**RE:** Alexander House  
SITE PLAN AMENDMENT No. 81989071A

RE: Elizabeth Square; Project Plan # 920150010;  
Preliminary Plan Amendment # 120150030

RE: Preliminary Plan No. 120150030  
Elizabeth Square

PROJECT NUMBER: 713-B3  
DATE: MARCH 30, 2015  
SCALE: As Shown  
DRAWING TITLE: FIRE ACCESS PLAN ALTERNATE EXB-2  
DRAWING NUMBER:

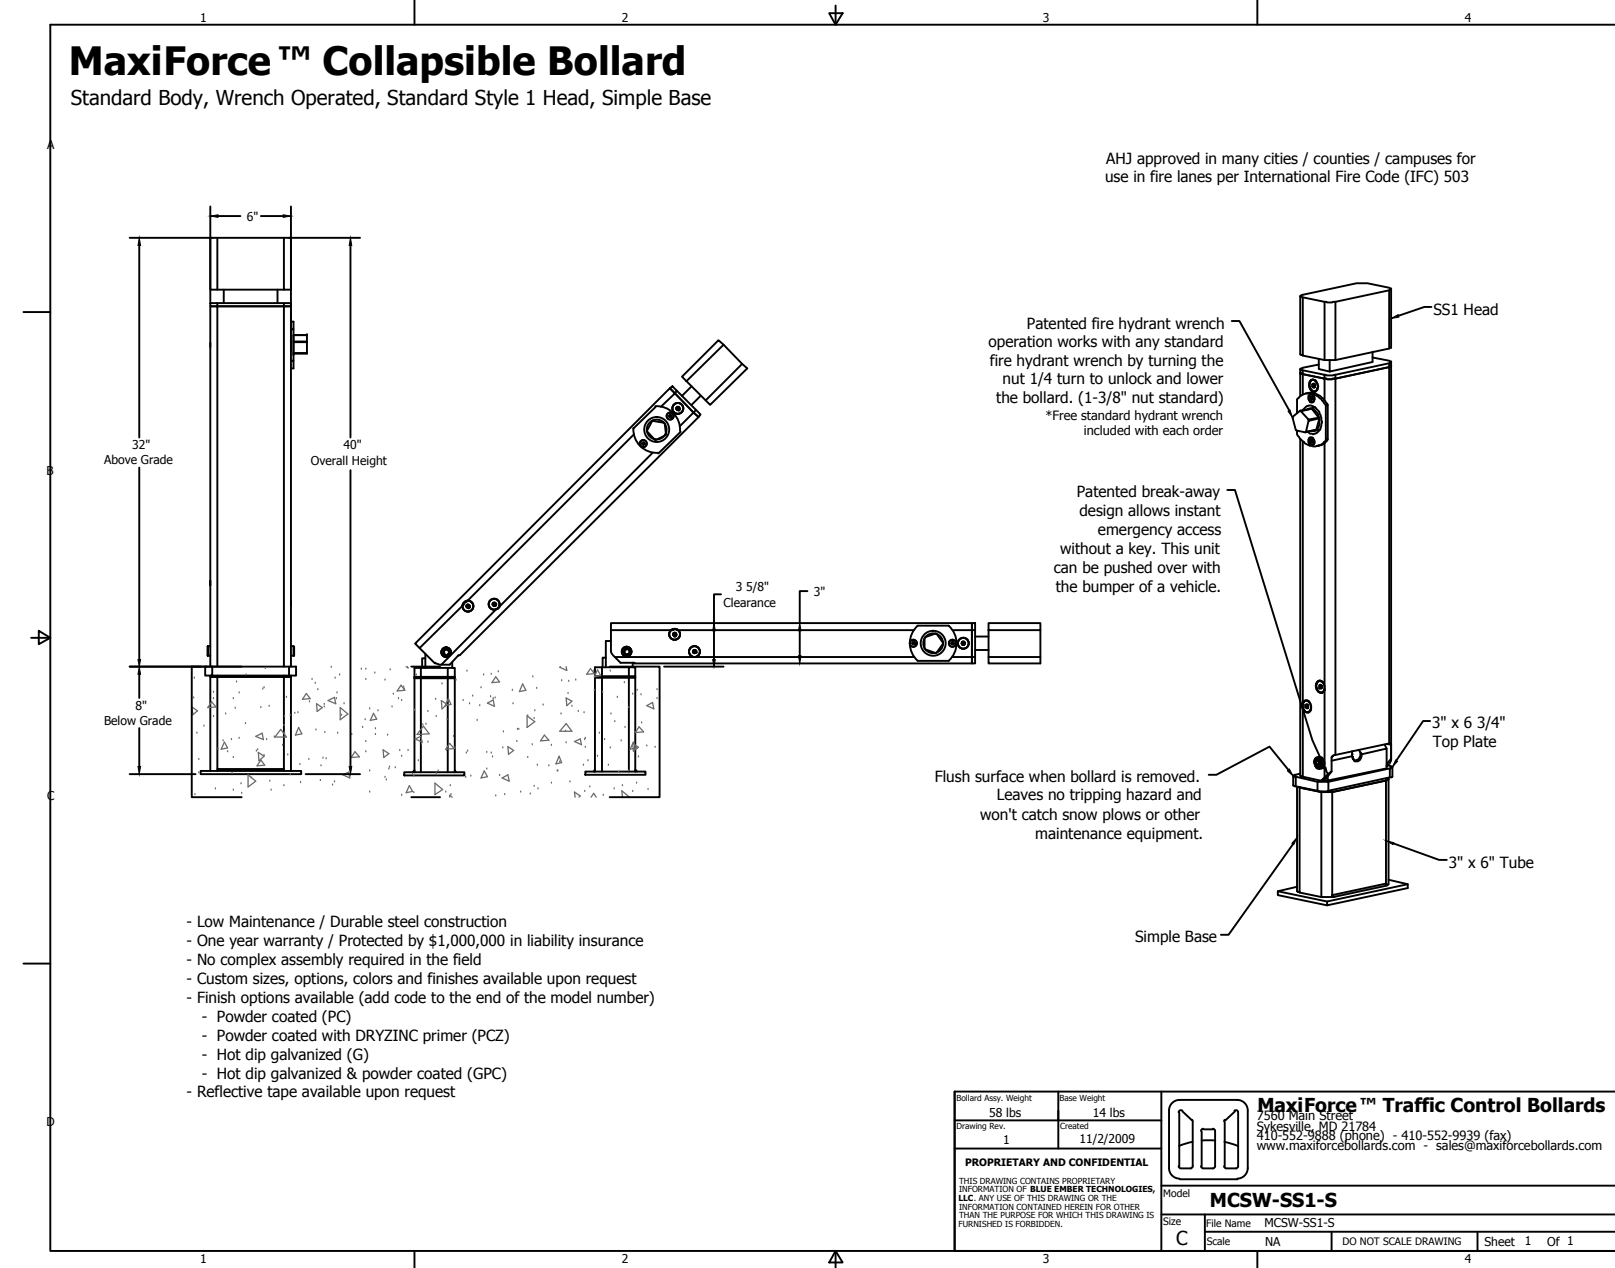
Ok, we can remove the loop fire apparatus access on CCT. We will only provide the (2) T-turnarounds at Fenwick & Apple within the trail, and the trail between the T-turnarounds will not be fire department accessible.

I am sorry, I thought I had already responded. If DOT is more comfortable with the double-t tunaround that still uses the bike path, I am ok with that. I would like to see a plan to confirm my impression of the details.

I do not have a plan in front of me: does this mean that the turnarounds will still utilize part of the bike path?

Thank you for the clarification, we will submit plans with fire access as indicated above.

- Meeting minutes from 01/27/2015 meeting.
- Fenwick Lane
- Apple Avenue
- Fire Access Plan

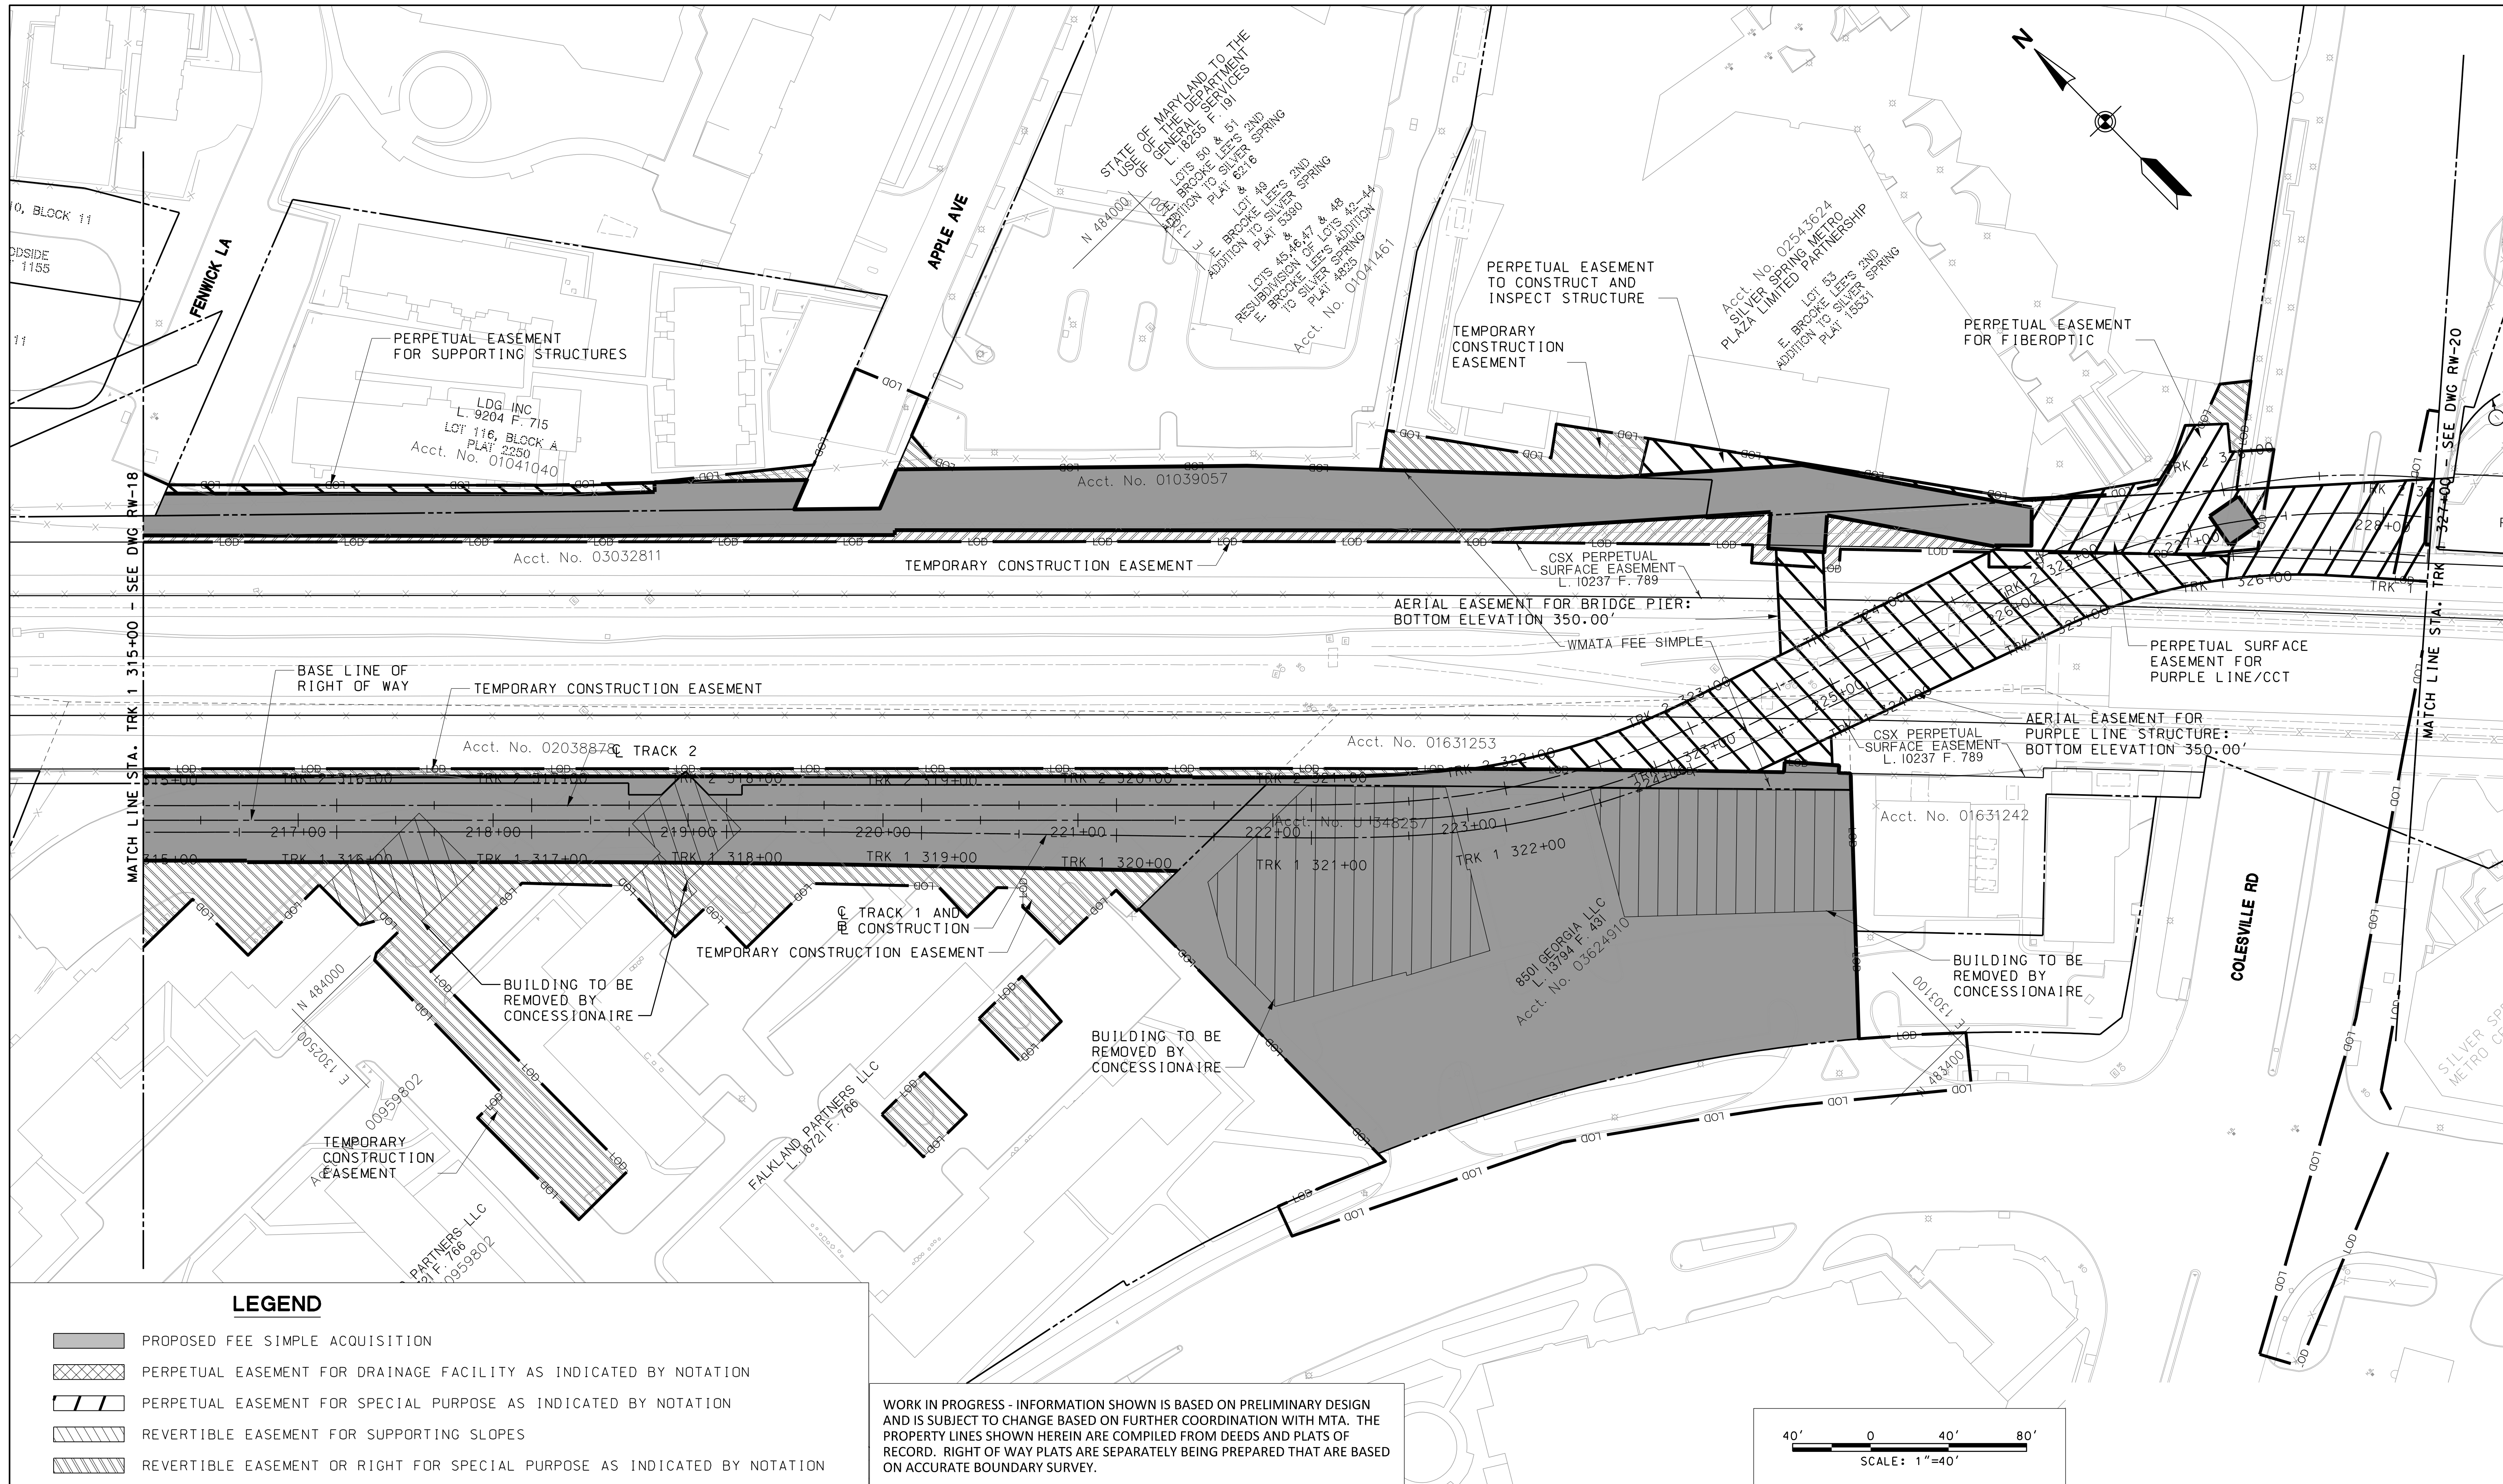
The applicant will be preparing revisions to the attached plans, per our meeting with MCFRS staff. Once completed we will provide updates.
